Project	IEEE 802.16 Broadband Wireless Access Working Group < http://ieee802.org/16 >	
Title	Enhancing the Procedure Flow in WirelessMAN-CX Operating Stage----Methods to Fairly Use Channels in WirelessMAN-CX Operating Stage	
Date Submitted	2007-03-05	
Source(s)	Liwen Chu STMicroelectronics 1060 East Brokaw Road San Jose, CA, USA	Voice: 1-408-467-8436 Fax: 1-408-452-0278 liwen.chu@st.com
	George Vlantis STMicroelectronics 1060 East Brokaw Road San Jose, CA, USA	Voice: 1-408-467-8436 Fax: 1-408-452-0278 george.vlantis@st.com
Re:		
Abstract	This contribution proposes to enhance adaptive channel selection using 2-hop BS working channel ID to increase spacial efficiency.	
Purpose	To consolidate the working document	
Notice	This document has been prepared to assist IEEE 802.16. It is offered as a basis for discussion and is not binding on the contributing individual(s) or organization(s). The material in this document is subject to change in form and content after further study. The contributor(s) reserve(s) the right to add, amend or withdraw material contained herein.

Methods to Fairly Use Channels in WirelessMAN-CX Operating Stage

Change Figure h17 as follows:

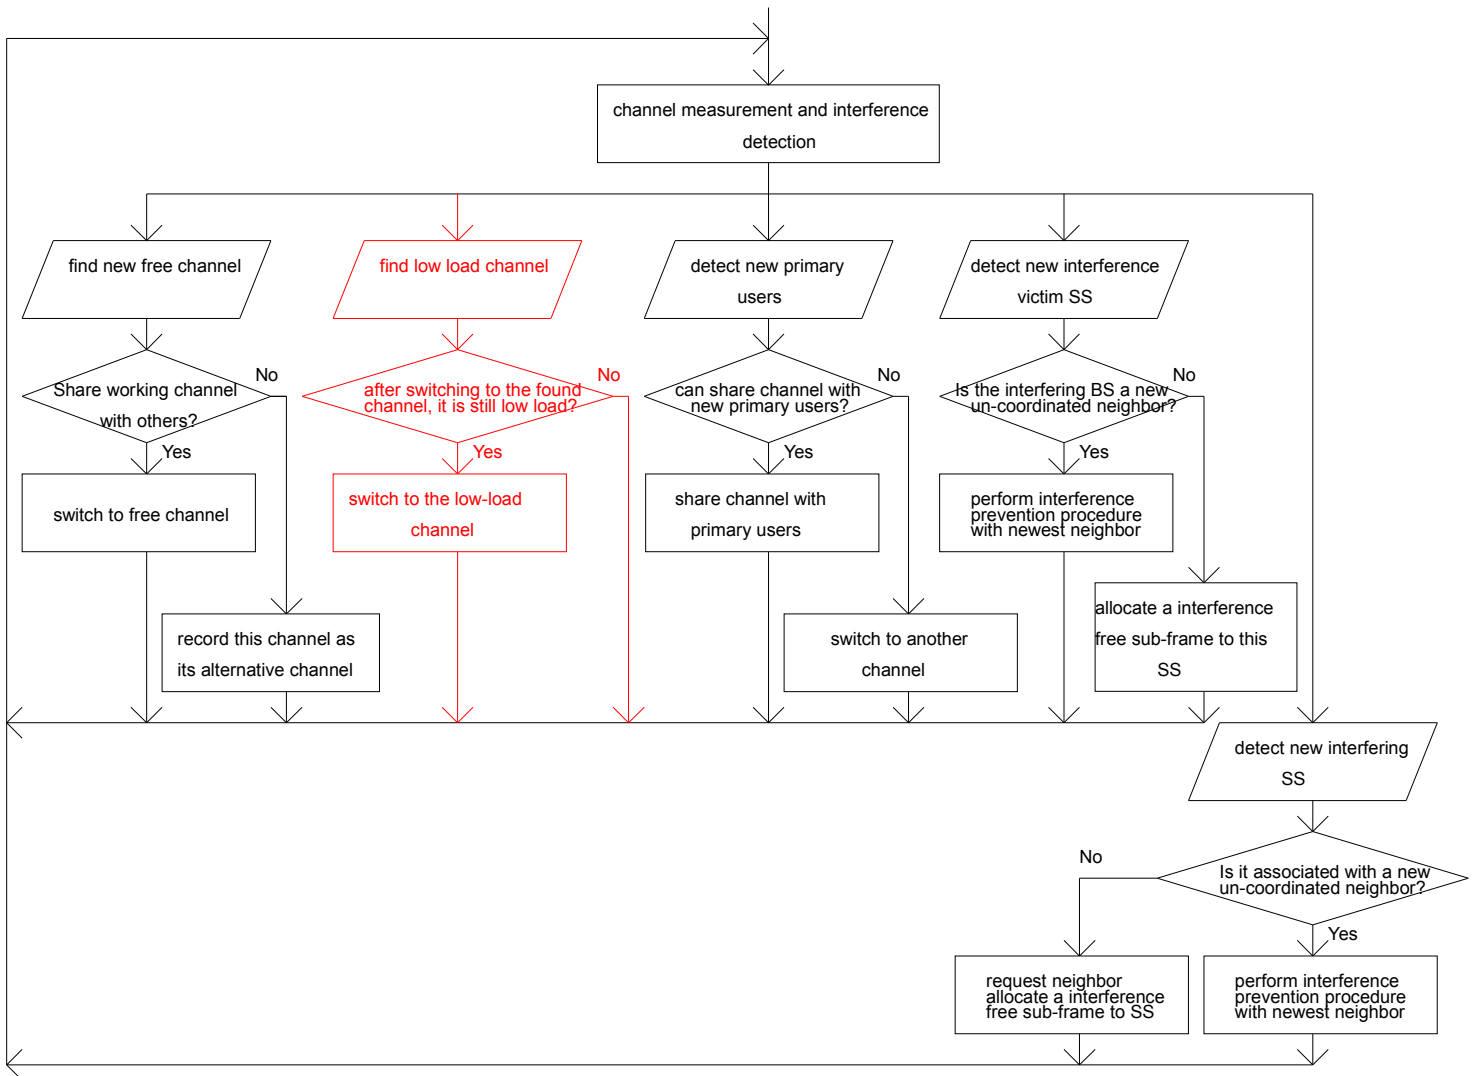
If , after a system in operating stage finds a channel with fewer systems and switches to it, the new working channel does not become more congested than the original working channel, the system may switch its working channel to the channel with fewer systems. The switching system may request its coexistence neighbors to delete it from their coexistence neighbor list by using CXP message. The switching system shall also negotiate with the systems working in the new working channel channel about the new frame structure, OCSI. The switching system may also update its neighbors with its new working channel, OCSI after it joins the new community.

If the interference from a interfering SS is released, e.g. if interfering SS powers off or leaves interference area, BS will check if all interference with one neighbor is released, that is, the number of victim SS interfered by the neighbor is zero and the neighbor of interfering SS which causes interference to the system is zero. If not, system may request its neighbor updates the resource allocation to this SS. If all interference with one neighbor is released, system may delete this neighbor in its coexistence neighbor list and update frame structure according to new neighborhood.

The higher priorities (smaller backoff periods) are given to the systems in more congested channels. The Systems with 3 (maximal value) overlapping neighbors working in the same channel has the smaller backoff window. The Systems with 2 overlapping neighbors working in the same channel has the larger backoff window. The systems trying to switch to a new channel select a random numbers from the backoff windows. A BS will generate a backoff period before it tries to switch its working channel to an idle channel or a channel with fewer systems working in it. During the backoff procedure, the BS and its associated SSs shall allocate more resource to measure the channel that it tries to switch to. In case another BS switch to that channel, the BS shall stop the backoff procedure. If the channel is still a sparsely used channel, the BS may start another backoff procedure or keep stay in the original working channel.
